Board of Trustees Regular Meeting Agenda Hartland Township Hall Tuesday, November 29, 2022 7:00 PM

Submitted By: Troy Langer, Planning Director

Subject: Site Plan with Special Land Use Application #22-015 (Mini warehouse establishment with outdoor storage as accessory to a permitted use)

P1 PHOTOMETRIC PLAN

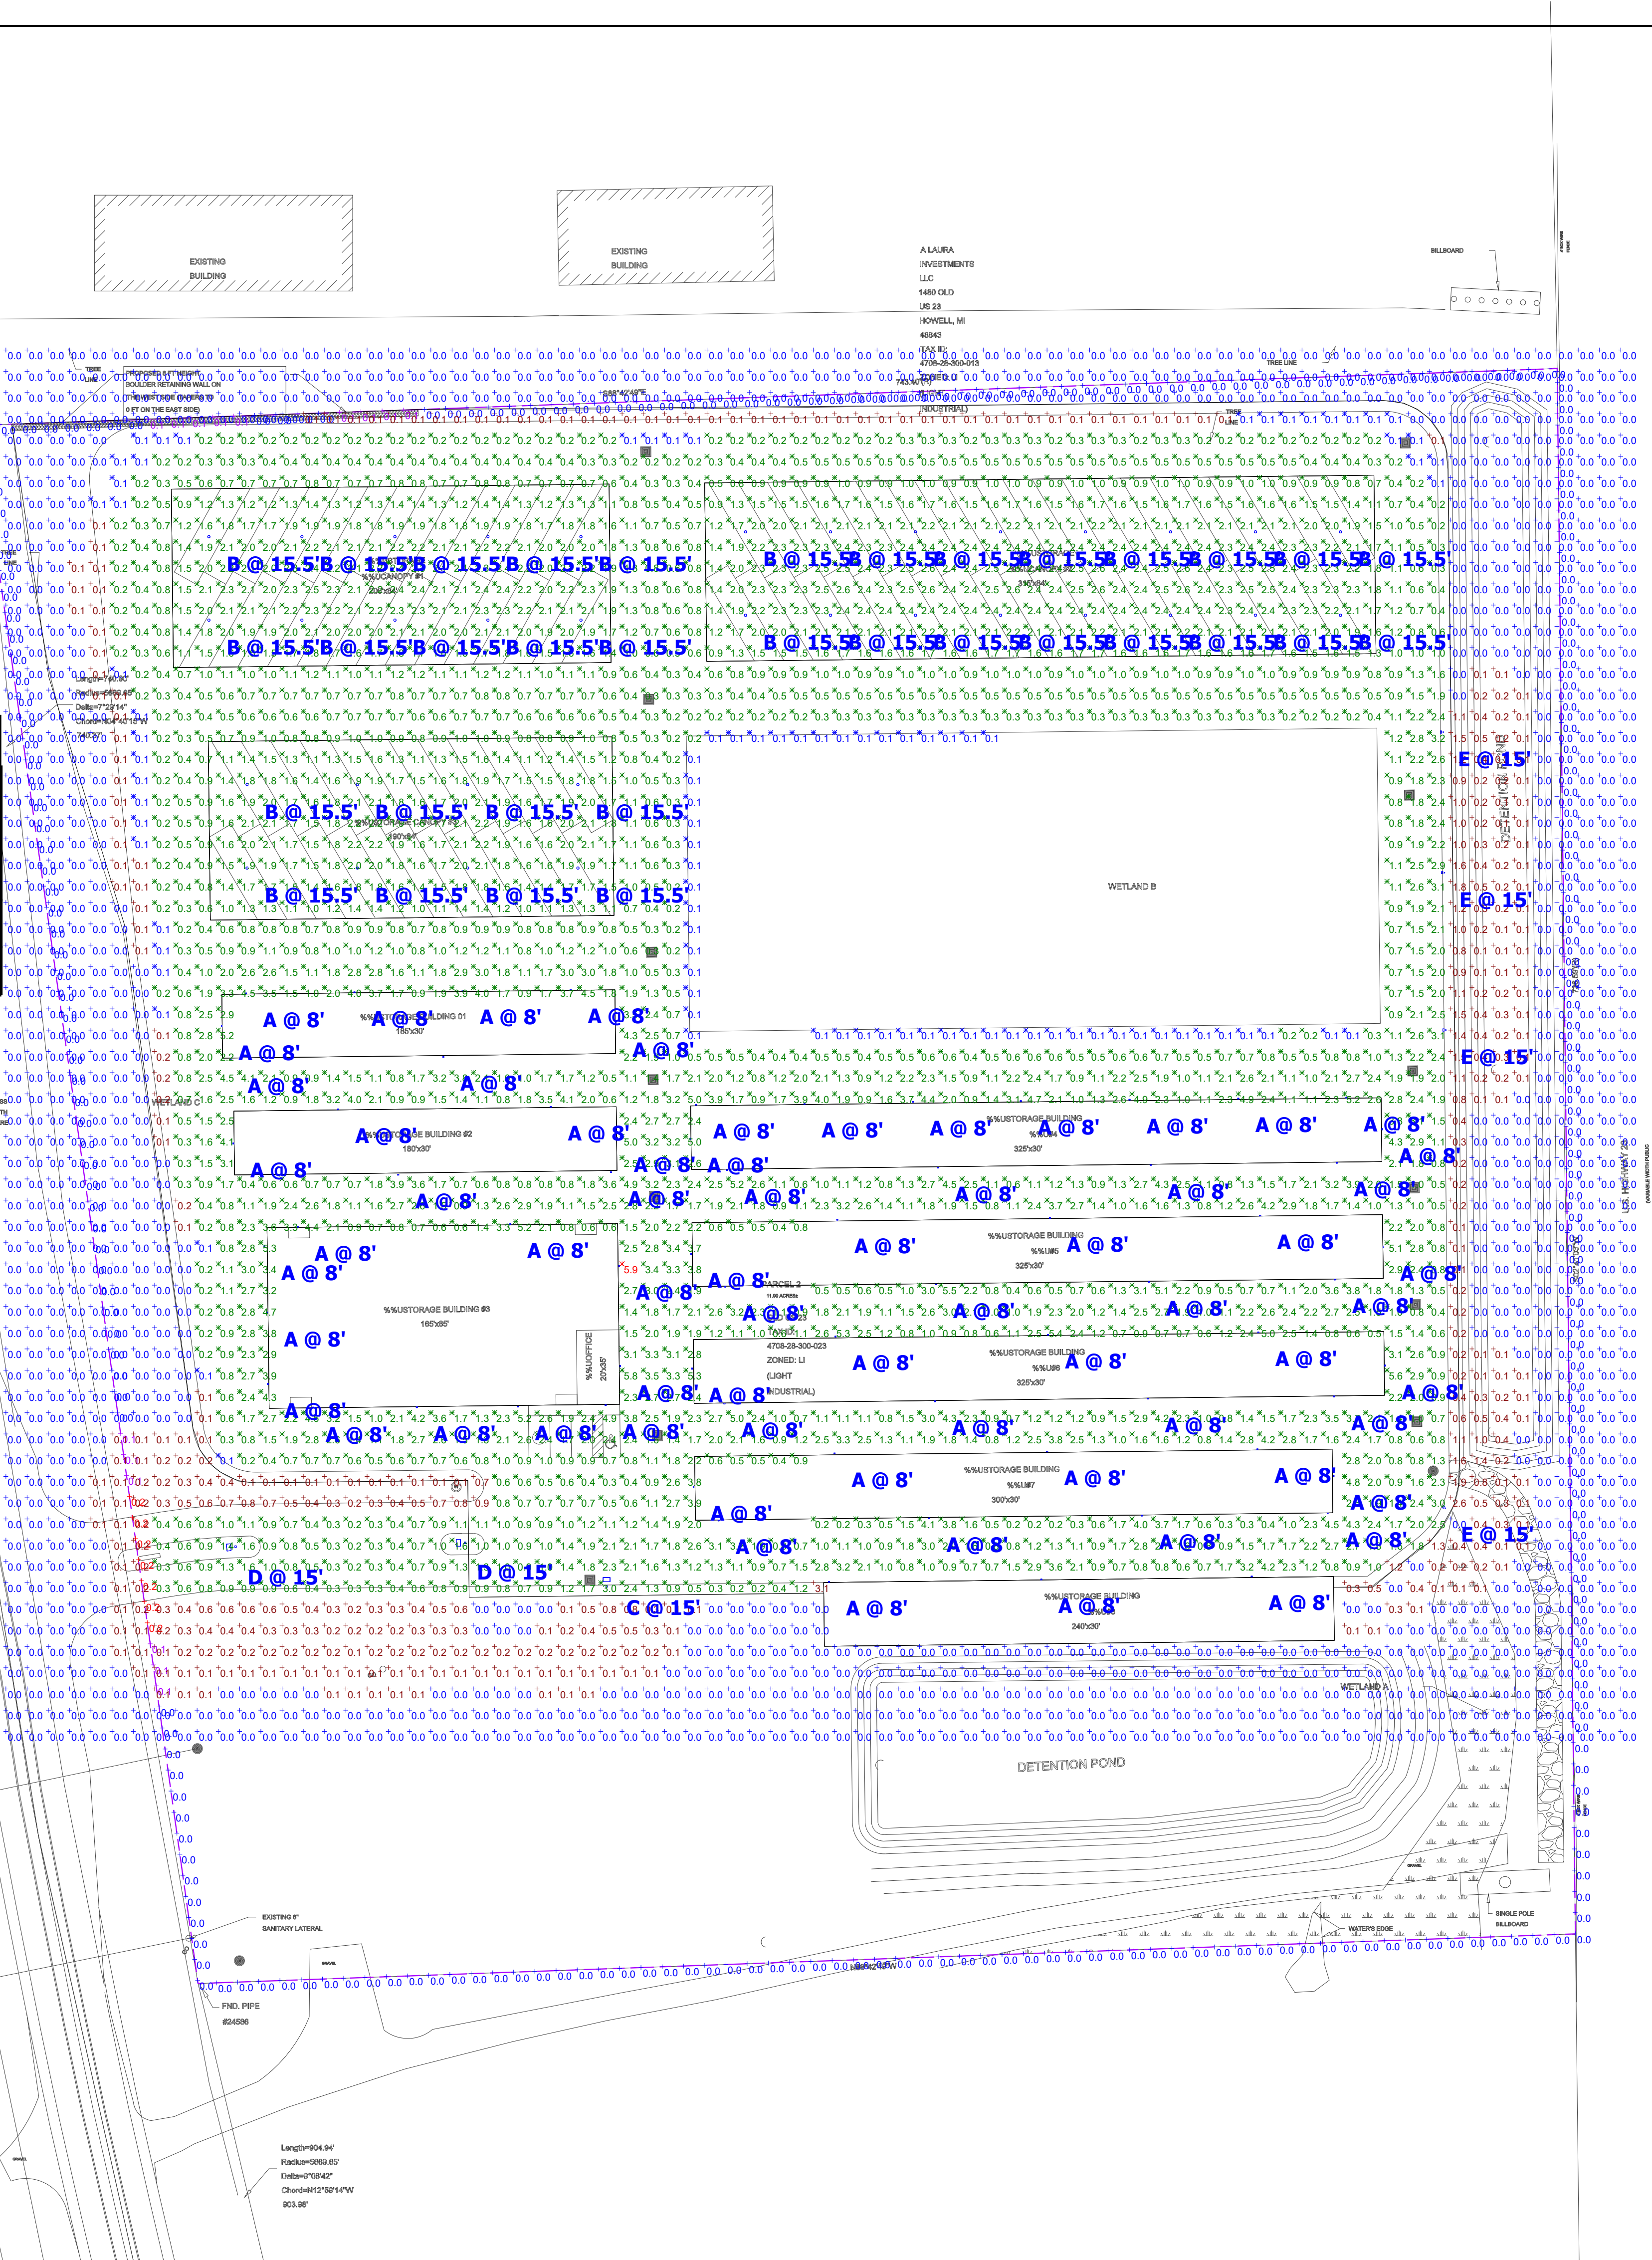
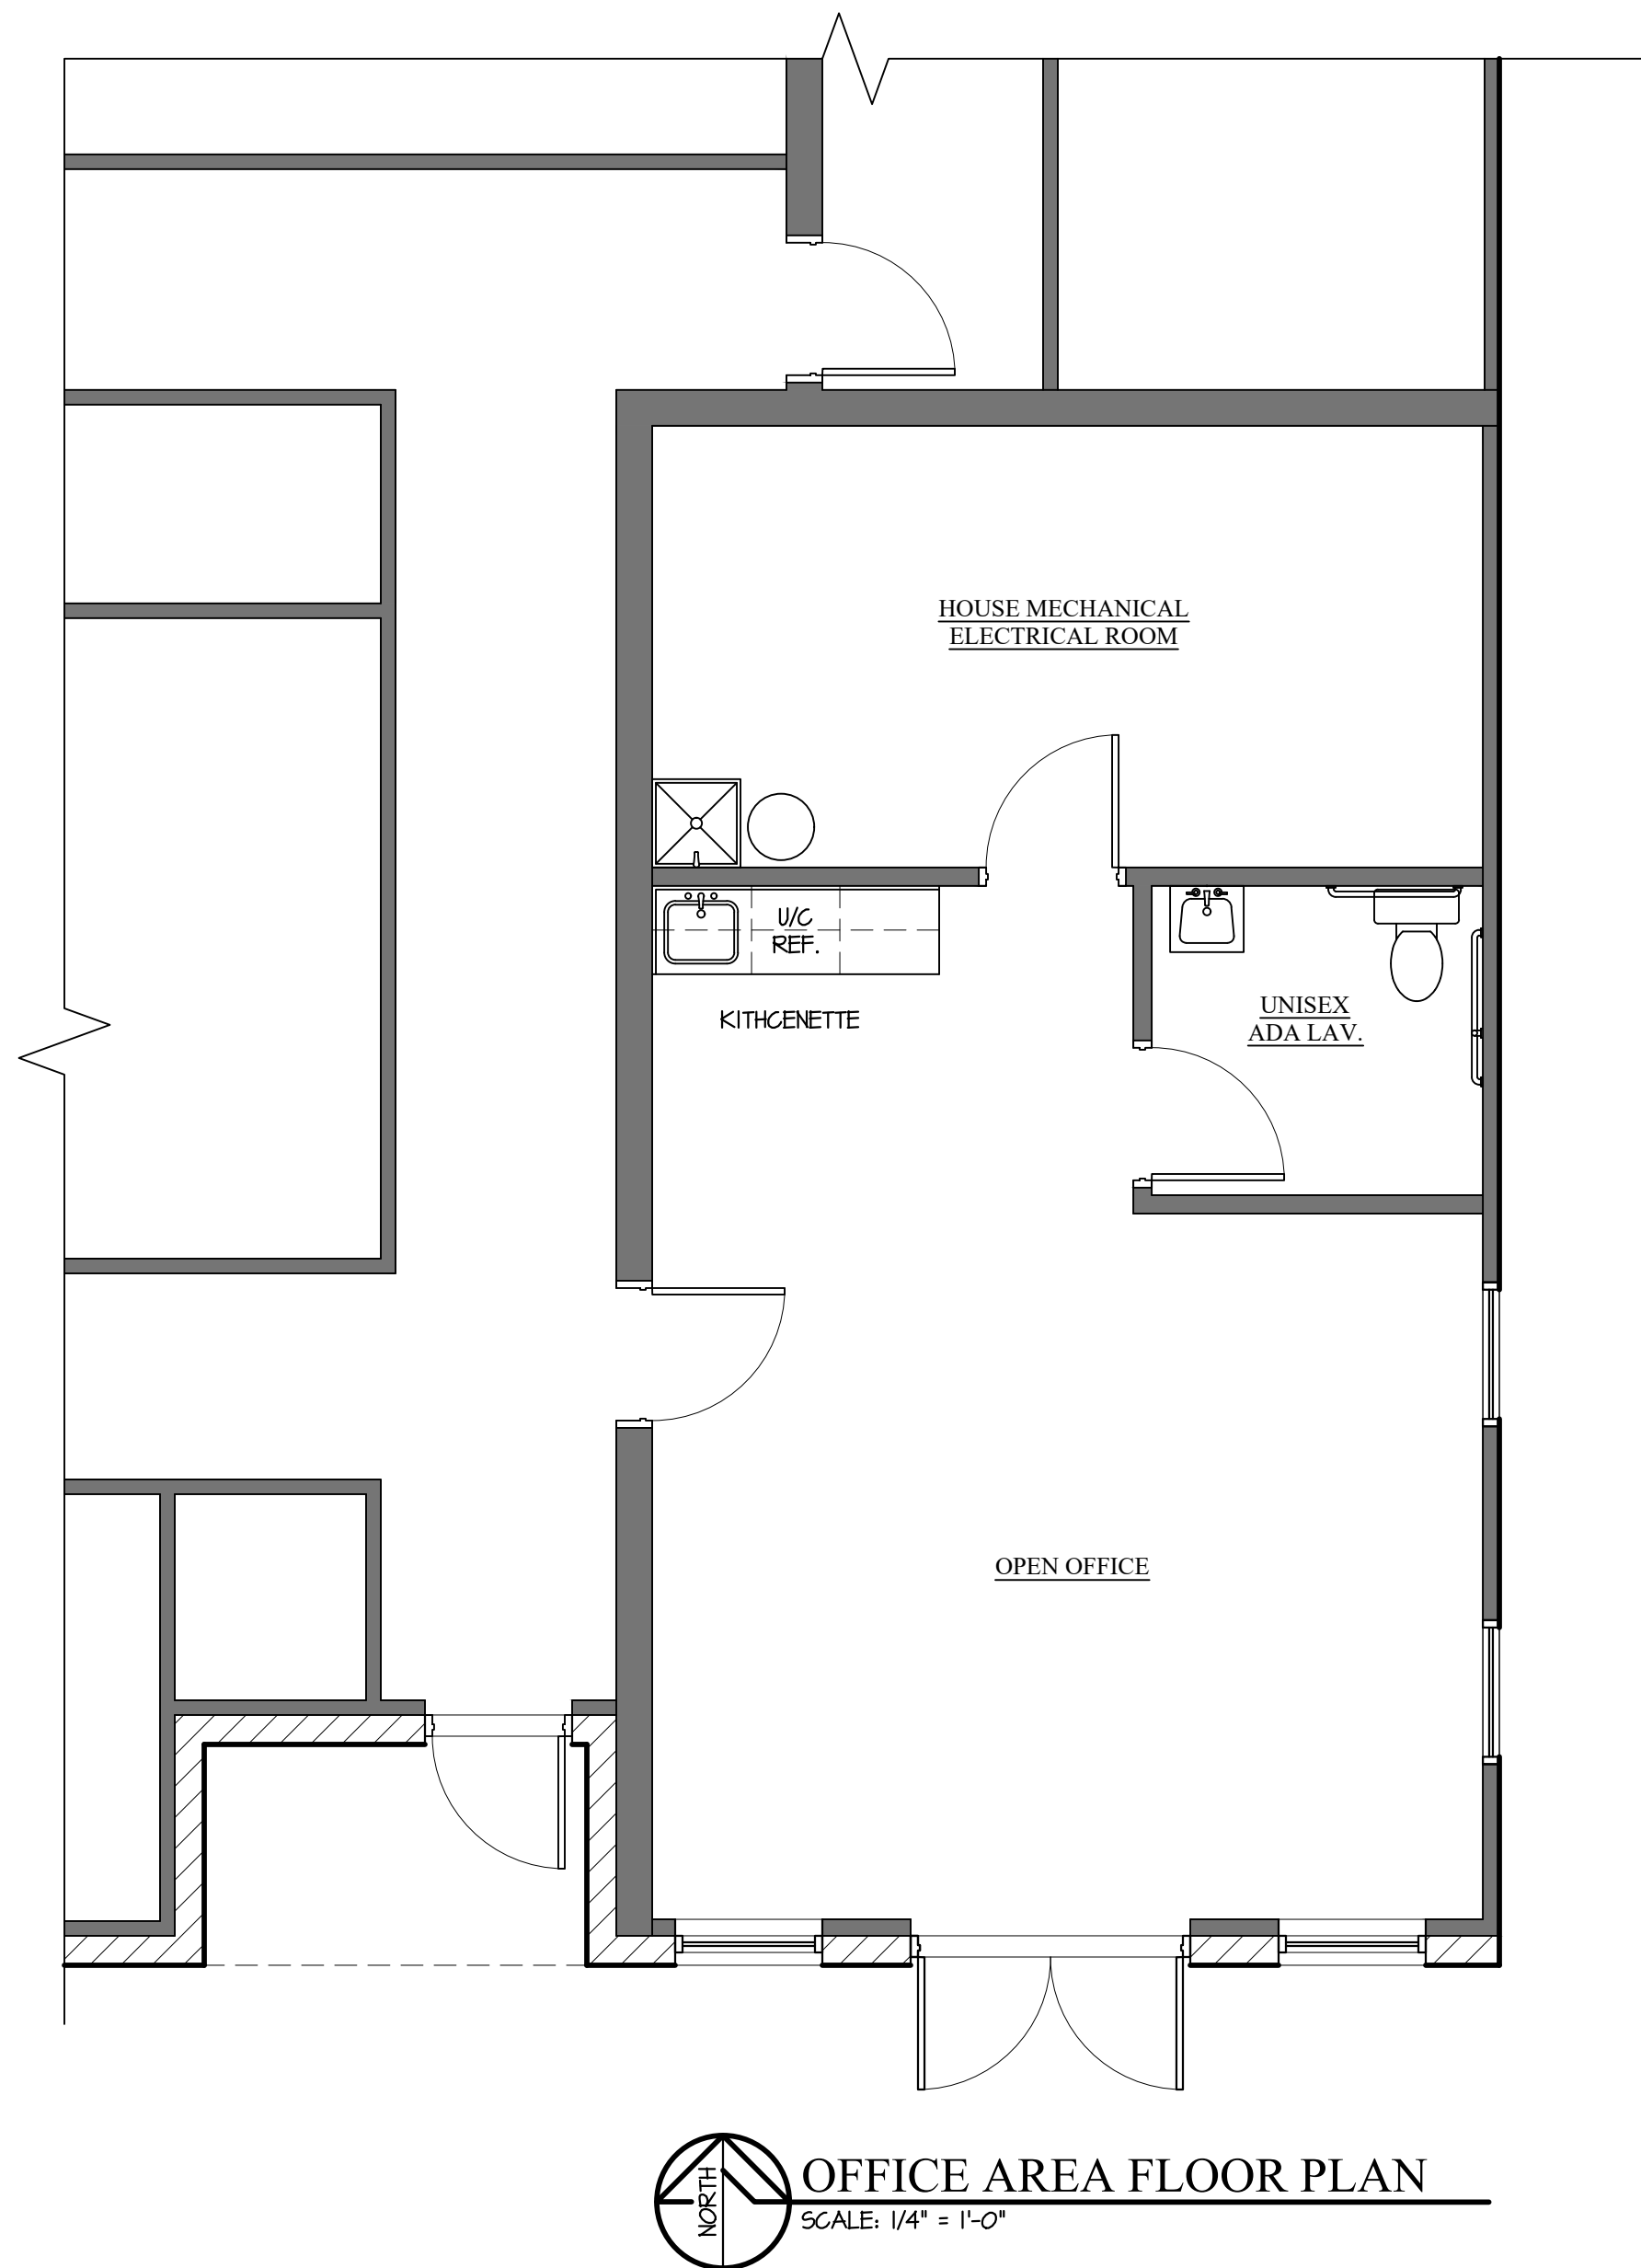
- Proposed – Photometric plan indicates 0.0 to 0.1 fc along each property line. Footcandle value less than 10 fc throughout the site. Information on average footcandle values in the main parking area, at main building entrance, and exit/entry drives was not provided. Footcandle values are measured at 0 feet above ground level and required height for measurement is 5 feet above ground level.

- Meets Requirement? – See notes below
- Comment – For this site intensity levels at the main exit/entry drive should be provided, but intensity levels at the main parking area and main building entry do not seem relevant, as there is a limited parking area and no designated main building (Building #3 at the office entrance could be of consideration). Photometric plan to be revised to measure the footcandle values at 5 feet above ground level and lighting intensity at the main exit/entry drive on the Construction Plan set.
